**LEISURE**  
TRAVEL VANS

## Campaign Update CA#8674

Subject: Pantry Door Hinge  
Affects certain 2017 Wonder models

- Photo
- 12 - #10 screws

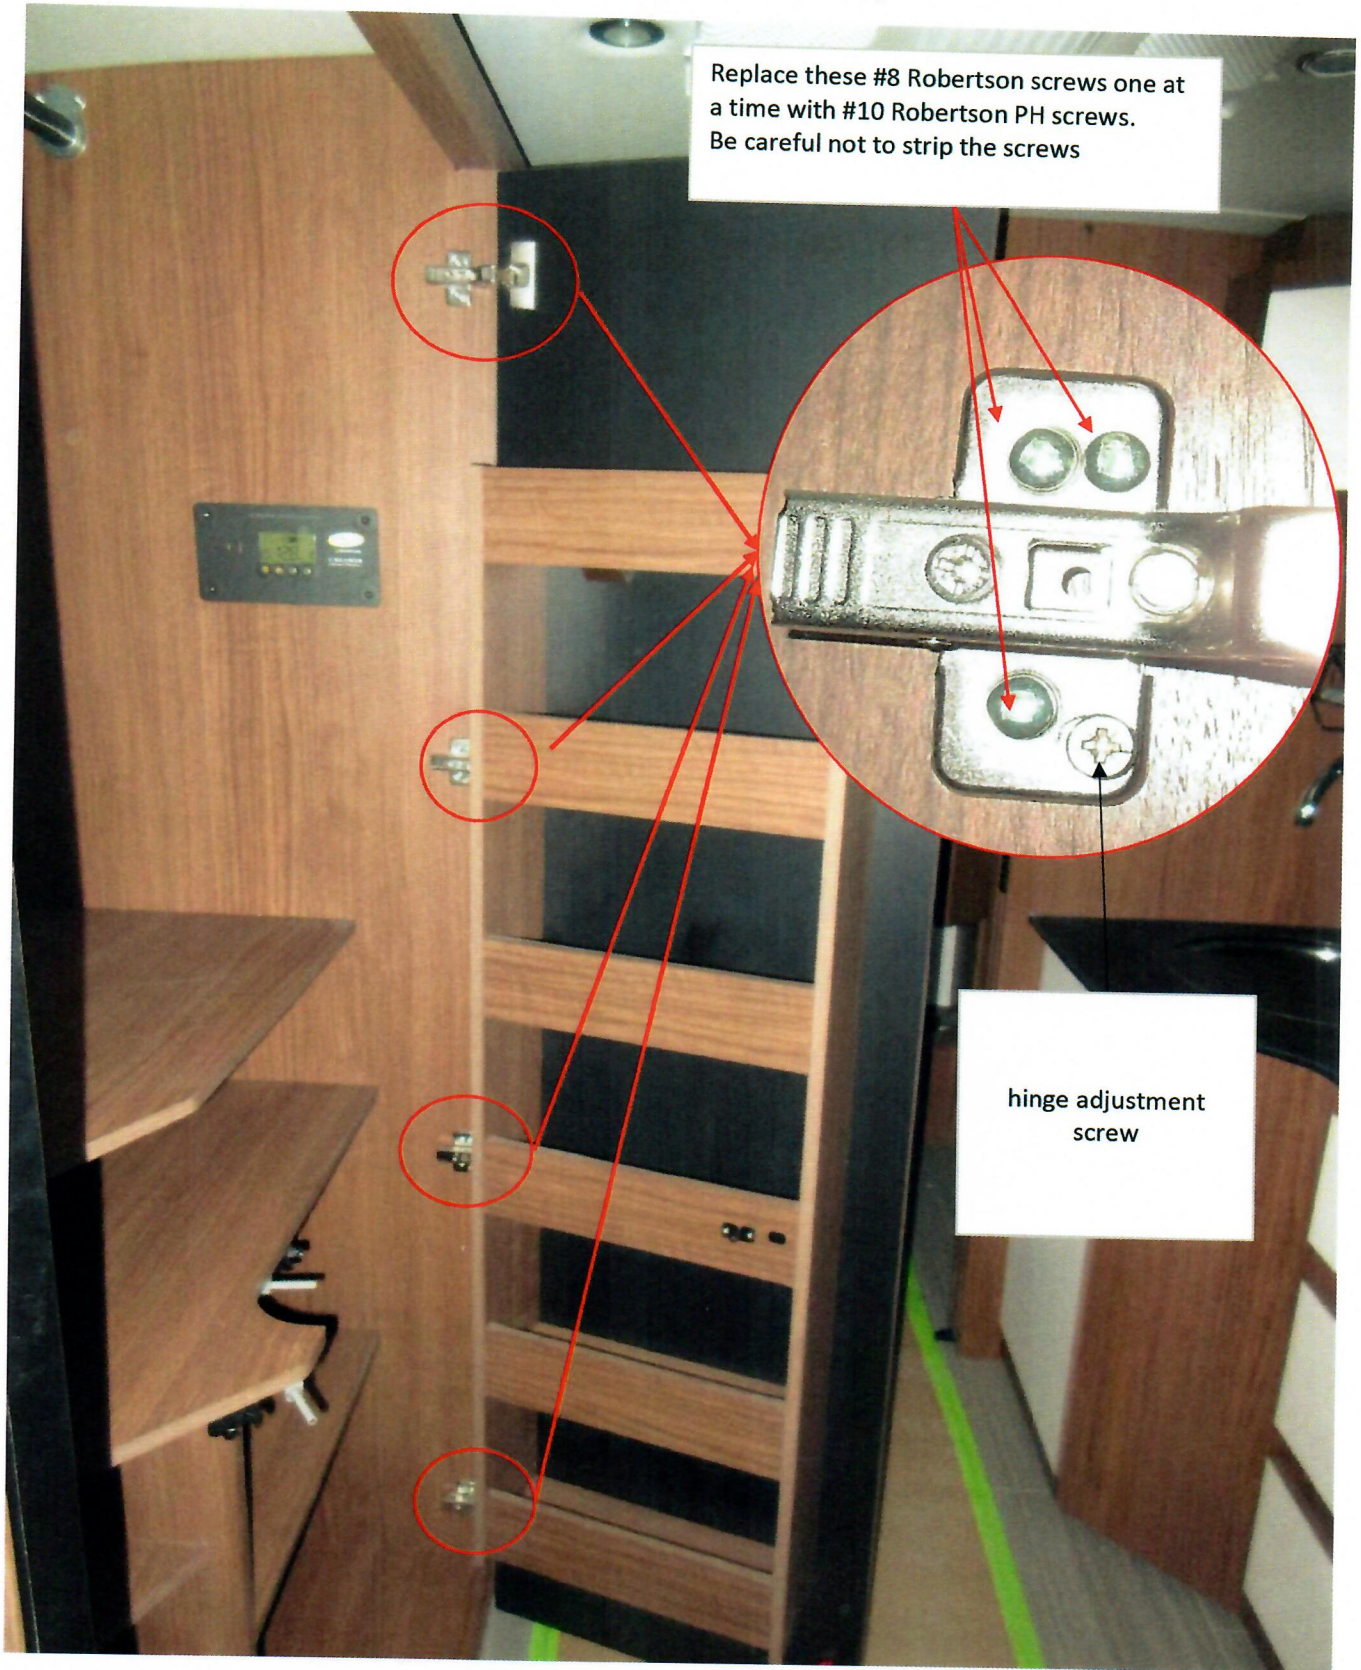
Replace these #8 Robertson screws one at a time with #10 Robertson PH screws. Be careful not to strip the screws

hinge adjustment  
screw

To correct this situation, please follow the enclosed instructions to install 12 - #10 screws included in this mailing.
